PLANNING AND ZONING BOARD STAFF REPORT

The Maxwell

Meeting	File No.	Application Type
June 16, 2025	2023-196-SPF-SPR-LV4	Level 4 Site Plan with waiver
Property Owner	Applicant	Authorized Agent
306 NE 2 nd Street LLC	Harold Van Arnem	Jon Kinsman

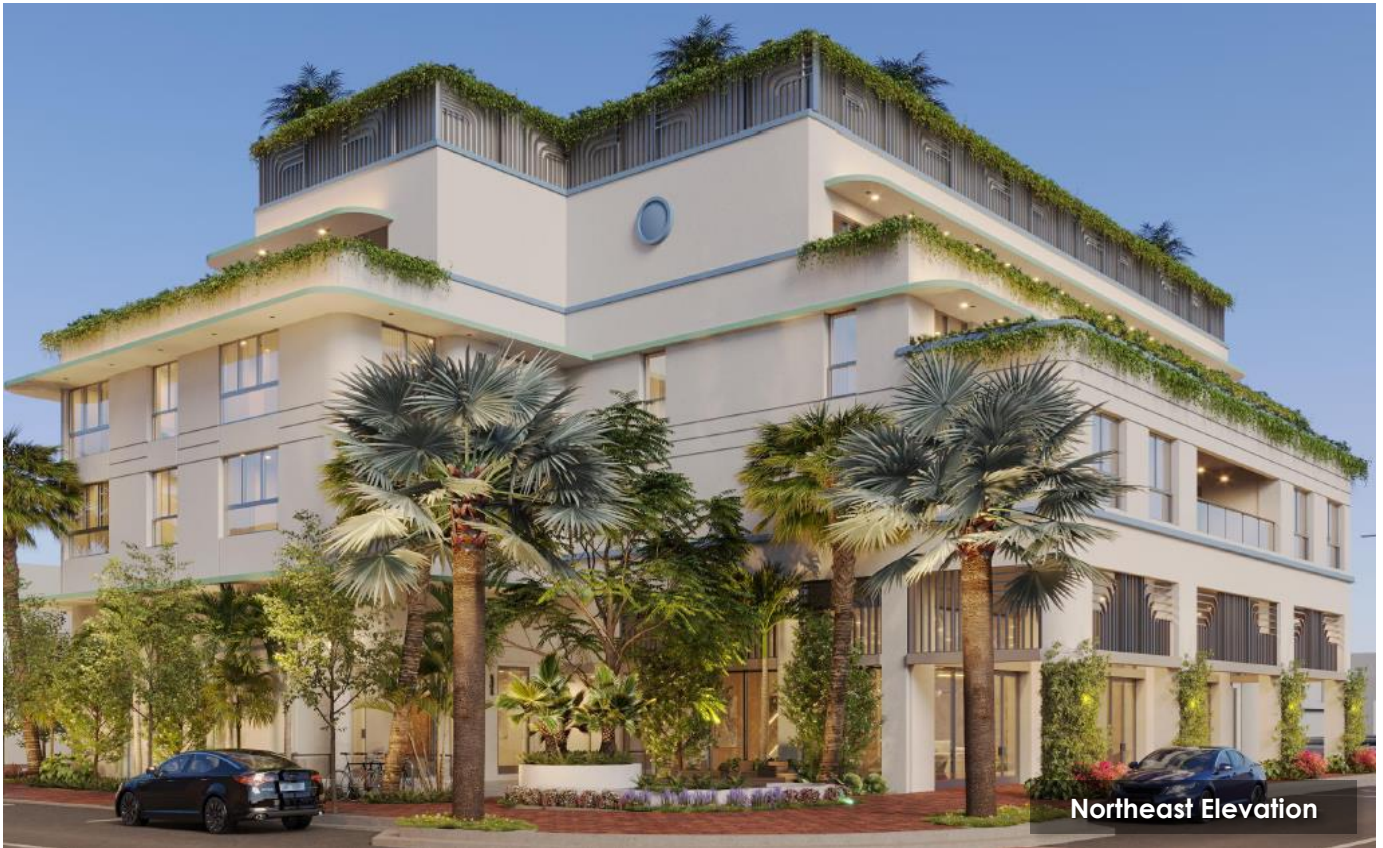
A successful Art Deco facade often consists of distinct sections—base, middle, and top—each with its own decorative treatment. The proposed design aspires to capture the grandeur of Art Deco, and its adherence to the style is evident. The proposed tripartite facades mass, with its clear division into base, middle, and top sections, provides a strong foundation and a sense of rhythmic progression.

The choice of stucco finishes, decorative aluminum screen, stucco wall medallion, custom ornamental parapet along with the proposed subdued blues, greens and gray pastel colors related to Art Deco style, primarily the examples seen in Florida. Smooth and sleek surfaces, paired with harmonious material combinations, reflect the luxury associated with Art Deco exteriors.

The design authentically captures the essence and visual impact of the Art Deco architectural style. The surrounding area consists of primarily Masonry Modern design. The design keeps with the modern aesthetic shown in the surrounding area, yet steps away from the masonry modern style and attempts a streamline Art Deco style, a style that is consistent with the permitted architectural styles outlined in the *Delray Beach Central Business District Architectural Design Guidelines*.

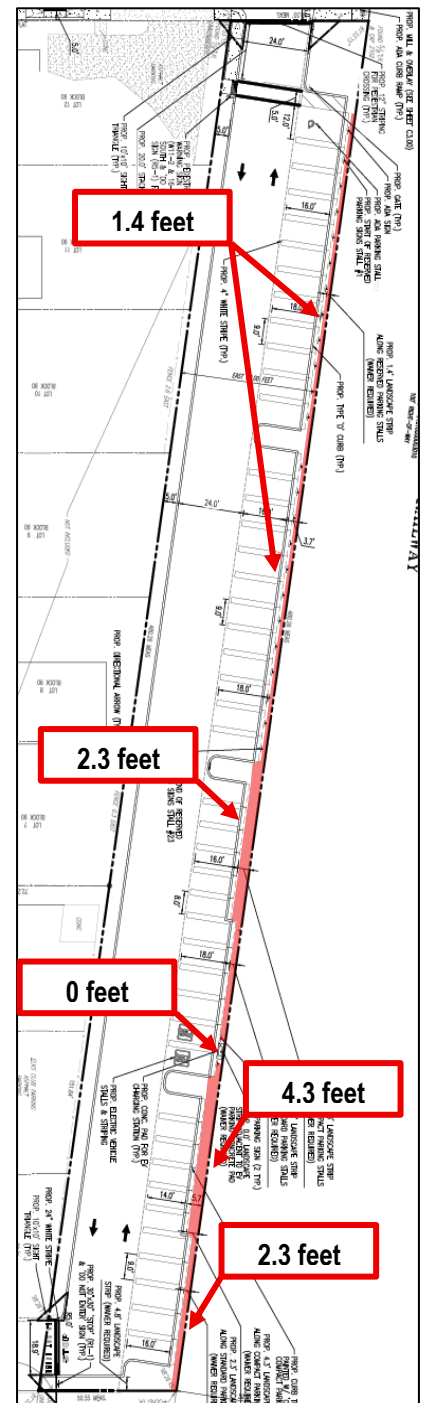
The current parking layout spans 480.26 feet long by 50 feet wide that allows vehicles to access the lot from NE 2nd Street and exit northward. Given the site's limited width, compliance with both the standard parking layout and the required 5-foot landscape buffer is not feasible without reducing parking capacity or reconfiguring circulation.

Additionally, a required 2-foot overhang cannot be included within the required 5-foot landscape buffer. The proposal also includes signage marking the residential reserved spaces and an EV concrete pad; the area where the signage and EV concrete pad is located cannot be included in the 5-foot landscape buffer. As a result, the proposed buffer varies in depth:

- **0 feet** where the EV pad is located.
- **1.4 feet** along the area with signage.
- **2.3 feet** in the remaining sections to the north.
- **4.3 feet** along a portion of the compact spaces

While the full 5-foot width is not maintained, the applicant proposes continuous landscaping within the reduced-width buffer areas. The landscape plan includes the required plant materials to the extent feasible, and efforts have been made to preserve visual screening along the right-of-way through enhanced planting design within constrained areas. The variation in buffer depth has been designed to minimize visual disruption and maintain an aesthetically cohesive frontage.
